### MEMORANDUM

**TO:** Cochise County Planning and Zoning Commission  
**FROM:** Christine McLachlan, AICP, Planning Division Manager  
**FOR:** Daniel Coxworth, AICP, Development Services Director  
**SUBJECT:** SU 23-26 (Cochise Stronghold Solar), Application for a Special Use Authorization  
**DATE:** October 31, 2023, for the November 8, 2023, Meeting

### APPLICATION FOR A SPECIAL USE (SU 23-26 Cochise Stronghold Solar)

Figure 2: Conceptual Site Layout

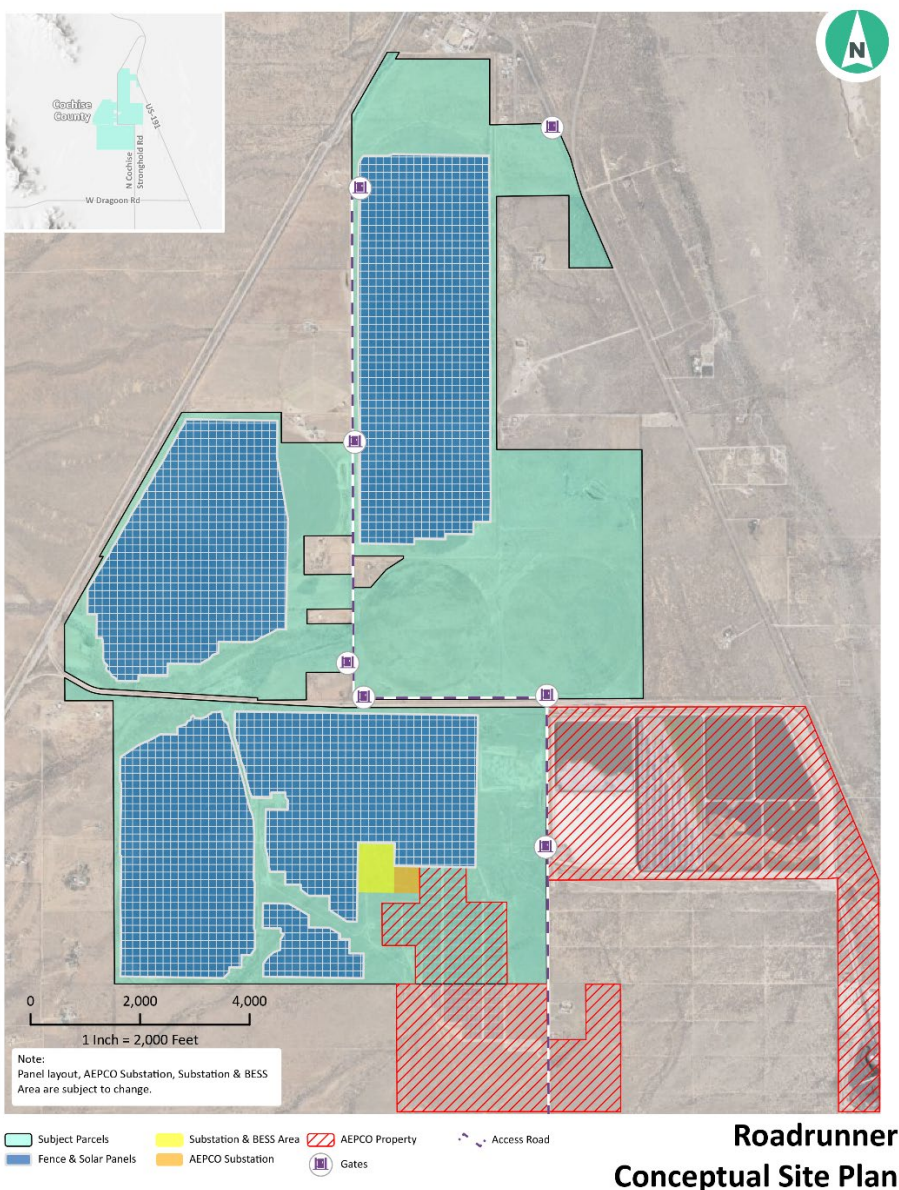
See Section III: Request Description and Figure 2: Conceptual Site Plan. This request includes portions on the following APNs: 20401020 (237.89 Ac), 20401022C (427.2 Ac), 20418001 (159.43 Ac), 20418003A (198.74 Ac), 20422001G (488.53 Ac), 20506004 (612.17 Ac), 20507001 (313.08 Ac), which equates to approximately 2,437-acres of rural-zoned land. It is immediately adjacent to the Apache Station and a permitted solar energy power plant that is leased to SSVEC. The concept plan indicates the location of the subject parcels, fence line, solar panels, as well as a future substation with a BESS. Both the substation, which is a permitted use in rural zoning, and the BESS are internal to the project site. As is typical for these projects, the BESS and substation are co-located.

- ***Recommended Waiver: The commission grants a waiver from setback required to internal parcel boundaries. Instead, minimum setbacks of 40’ shall only be applied to the exterior boundaries of the Project indicated by the concept plan.***
- ***Recommended COA: The project owner shall preserve no less than a 100-foot buffer from the edge of all developed residential lots to the edge of a solar-panel array. No less than a 1,320-foot buffer shall be provided from Cochise Elementary school to the edge of any solar panel array.***

12. The commission grants a waiver from setback required to internal parcel boundaries. Instead, minimum setbacks of 40' shall only be applied to the exterior boundaries of the Project indicated by the concept plan.

Figure 4: University of Arizona Energy Opportunity Analysis Map

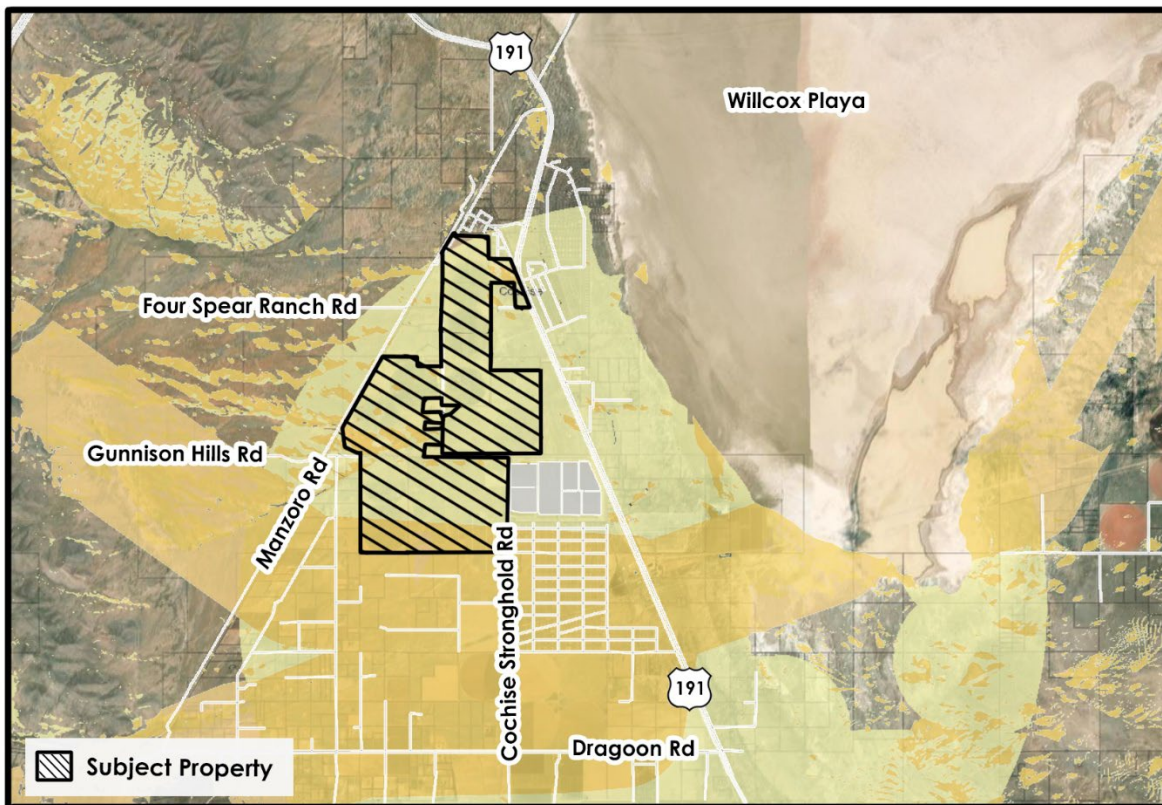
Approval of this project will, in part, implement the County’s goals of encouraging renewable energy. Policy A of Goal 1 refers to the University of Arizona’s Renewable Energy Opportunity Analysis to help determine locational suitability. Figure 5 superimposes this analysis on top of the proposed project site limits. Areas in yellow and orange are very well suited for solar energy production.

Figure 6: Floodplain Map

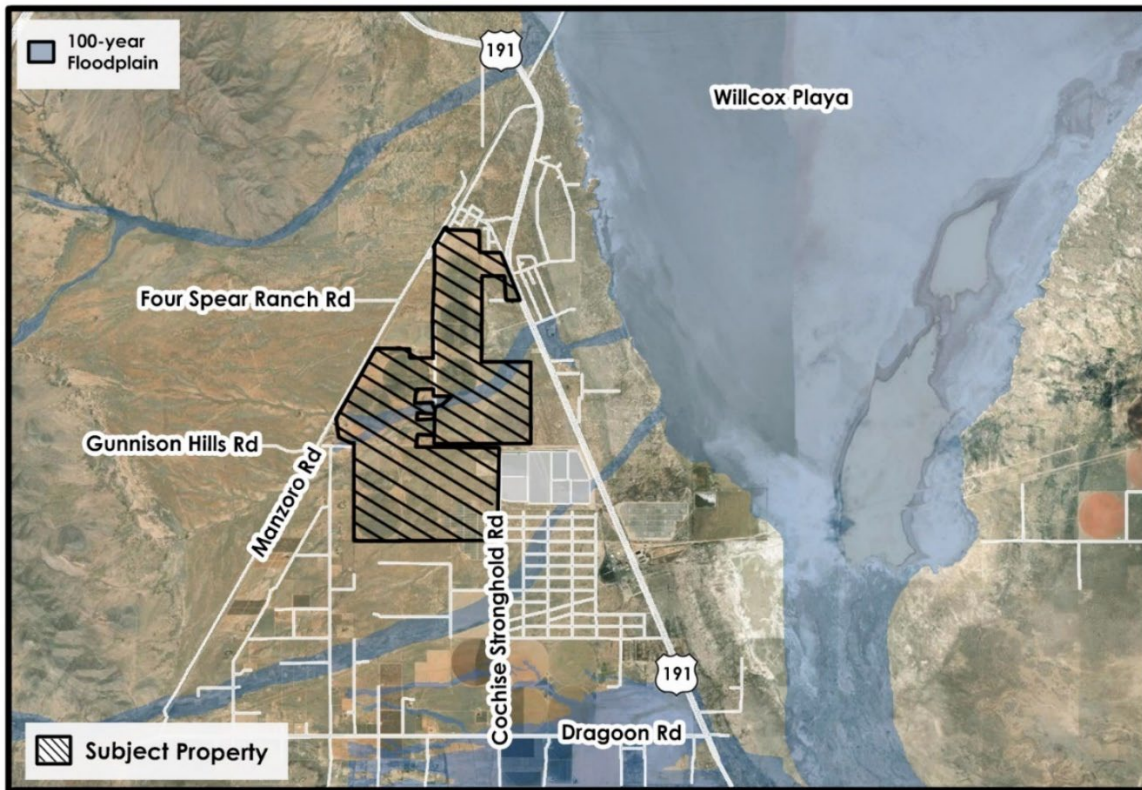
- Stormwater and Floodplains: A portion of the site is within the 100-year floodplain, as indicated on the graphic, below. The County will require a drainage analysis and floodplain use permit for the site during commercial permitting, if approved for special use authorization.

- **Recommended COA: Area within the 100-year floodplain shall remain free of any solar modules, batteries, inverters, transformers, and internal security fencing.**

10. Area within the 100-year floodplain shall remain free of any solar modules, batteries, inverters, transformers, and internal security fencing.
11. The project owner shall preserve no less than a 100-foot buffer from the edge of all developed residential lots to the edge of a solar-panel array. No less than a 1,320-foot buffer shall be provided from Cochise Elementary school to the edge of any solar panel array.
